Vogle PEmails

Southern Nuclear Operating Company
Vogtle Electric Generating Plant Units 3 and 4
Request for License Amendment and Exemption:
Debris Screen Related Dimensions (LAR-16-000)

**Request for License Amendment Regarding
Debris Screen Related Dimensions
(LAR-16-000)**

Figure 1, Above Screen Spacing (Front View)

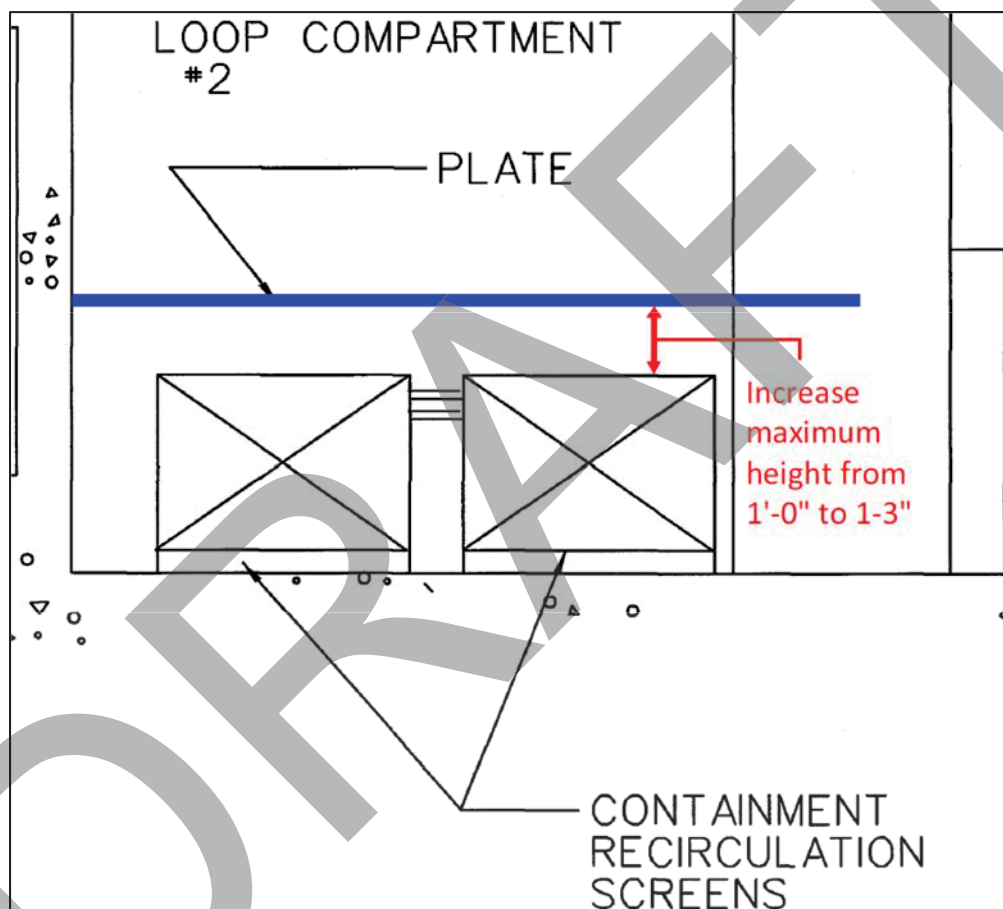
To address this inconsistency, it is proposed that the maximum distance of the plate above the top of the screen be increased to a height of 1 ft 3 in as shown in Figure 1

below. Note that this height requirement applies only at the required distances perpendicular to and to the side of the screens, as the corresponding debris transport evaluation, discussed further below, credits the height of the plate at these locations only. Changes are proposed to UFSAR subsection 6.3.2.2.7.1 to clarify this requirement. As discussed below in the technical evaluation that assesses the effect of this change on debris transport, this increased spacing does not adversely affect the design function of the protective plate, and thus continues to support acceptable screen performance.

Figure 2, Plate Extension Length (Top View)

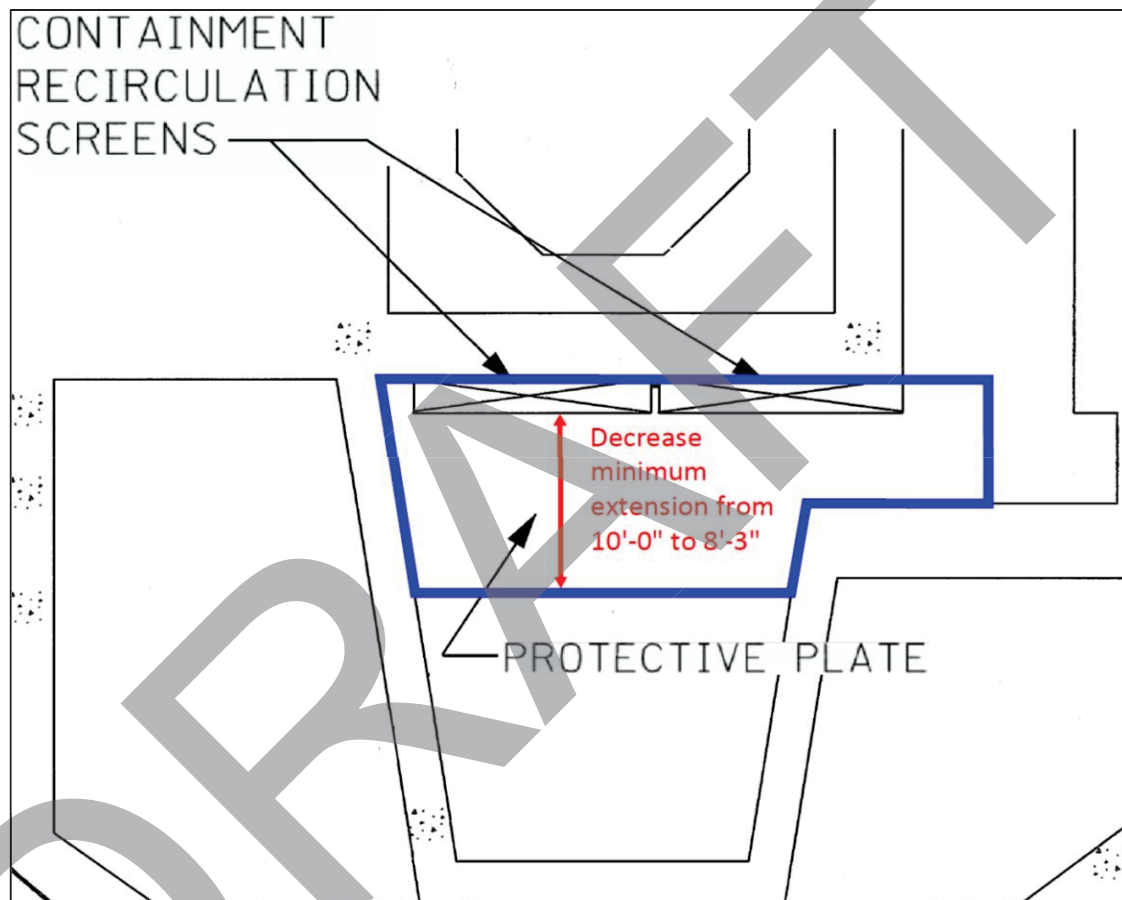
Additionally, it is proposed that the perpendicular extension of the plate beyond the recirculation screens be reduced from 10 feet to 8 feet, 3 inches as shown in Figure 2 below. This reduction increases clearance to support reactor coolant pump (RCP) removal and increases the accessibility for future maintenance. The proposed dimension changes affect COL Appendix C, plant-specific Tier 1, and the UFSAR identified minimum plate extension length from the front of the CR screens. The necessary licensing basis document changes are described in Table 3 below. As discussed below in the technical evaluation that assesses the effect of the change on debris transport, this reduction in plate length does not adversely affect the design

function of the protective plate, and thus continues to support acceptable screen performance.
